December 23, 1998

Reference: Addendum to the Workplan for Well Installation, Development, and Sampling
2585 Nicholson Street in San Leandro, California.
Versar Project Number: 4422-001.
Contract Number: 97-056, Work Order Number: 05582-02 , ES # 305582

Detailed By: AEC	 7844 MADISON AVENUE SUITE 167 FAIR OAKS, CA 95628 (916) 962-1612	2585 Nicholson Street San Leandro, California	Proposed Monitoring Well Locations	FIG 1
Scale 1 inch = 60 feet				
Project: X

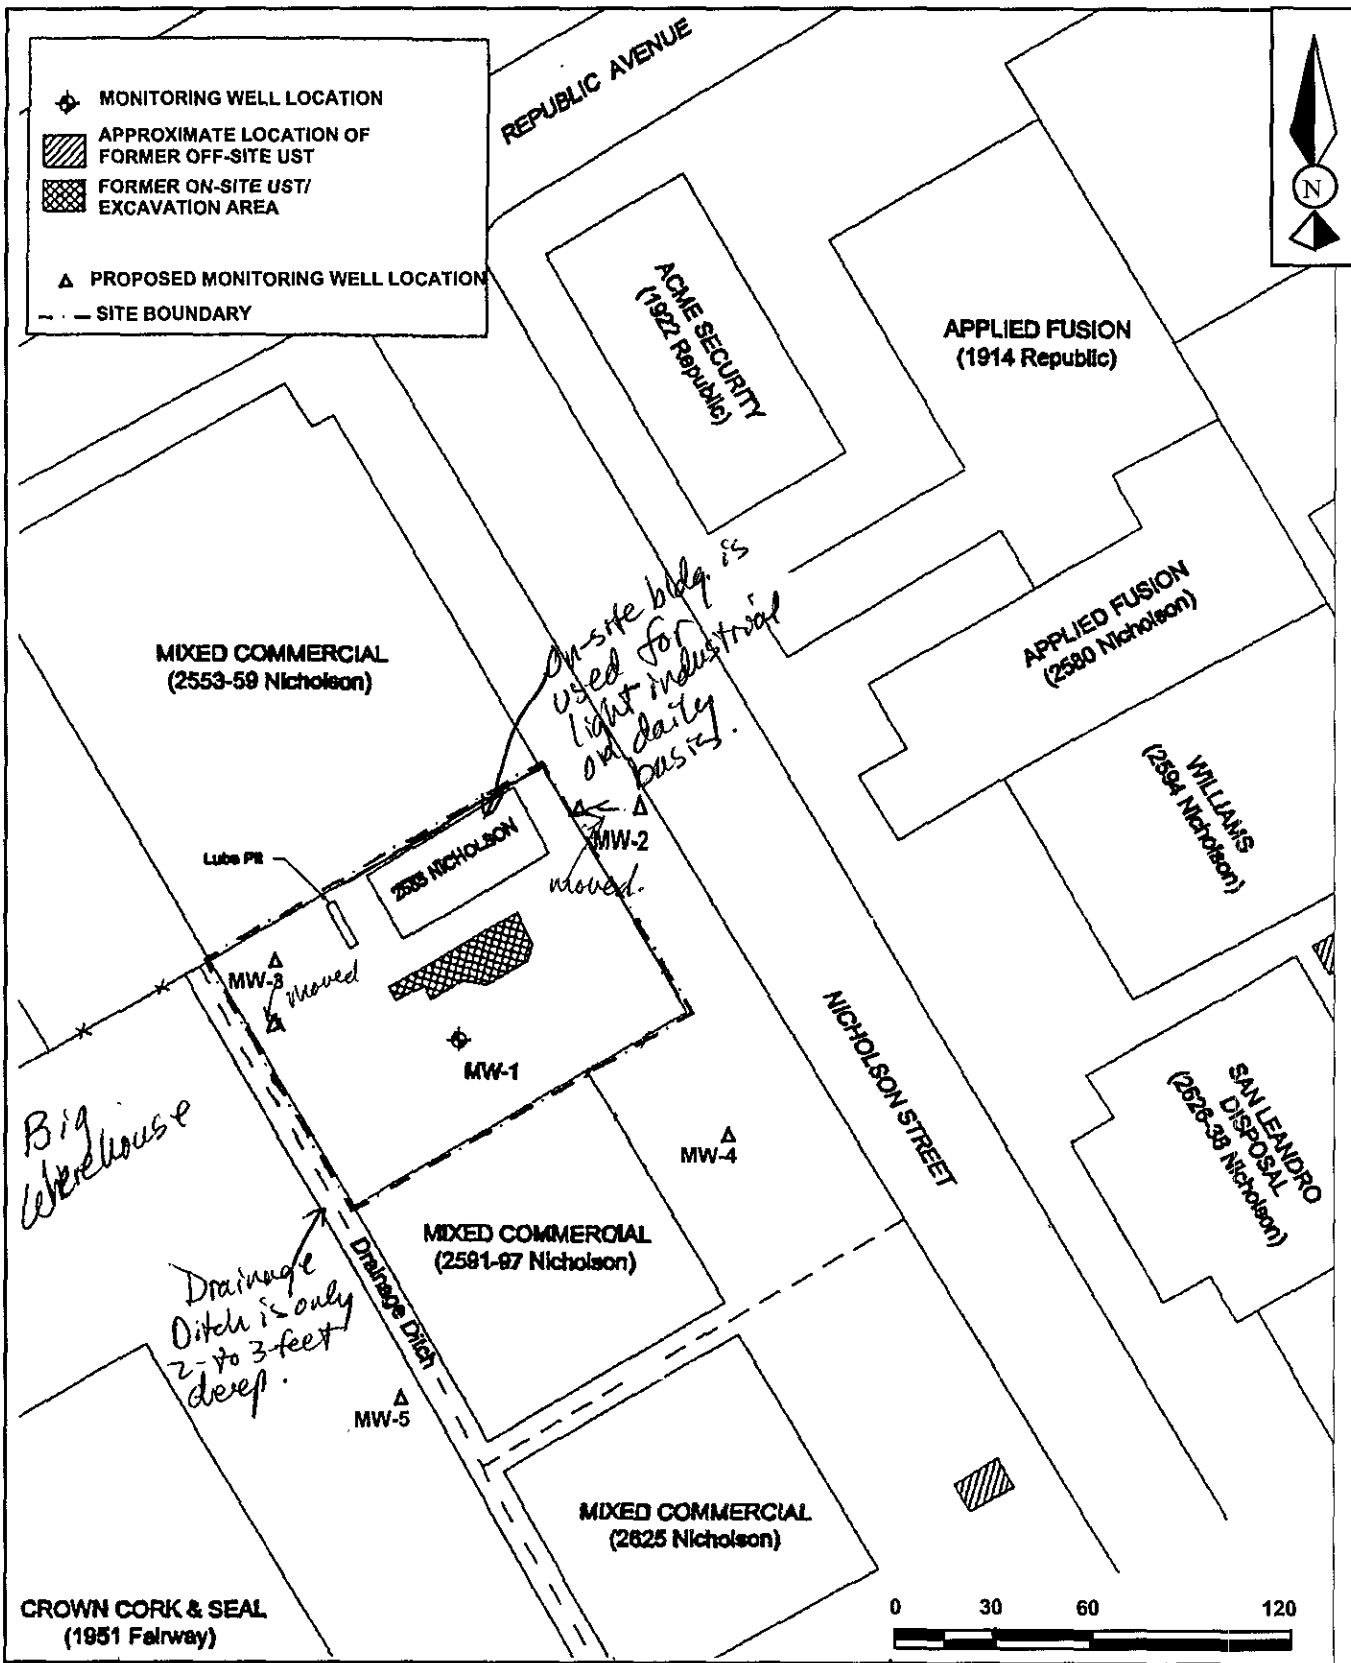
- 1) Paragraph 1 outlines modifications to the number and placement of the monitoring wells proposed for the Site. In general, we concur with your modifications. Bank of America requested Versar to install an upgradient monitoring well. However, Versar's review of

Not a good enough reason.
Somewhat McLaren Hart was able
to drill boring in location of
M-5.

underground utilities on the northeastern end of the Site indicated insufficient clearance to safely install the monitoring well. Subsequent discussion with the City of San Leandro Engineering Department indicates that an encroachment permit can be obtained to install the monitoring well on City property. The attached Figure 1 depicts the revised proposed monitoring well locations. The total number of monitoring wells that will be installed during this phase of work is amended to four.
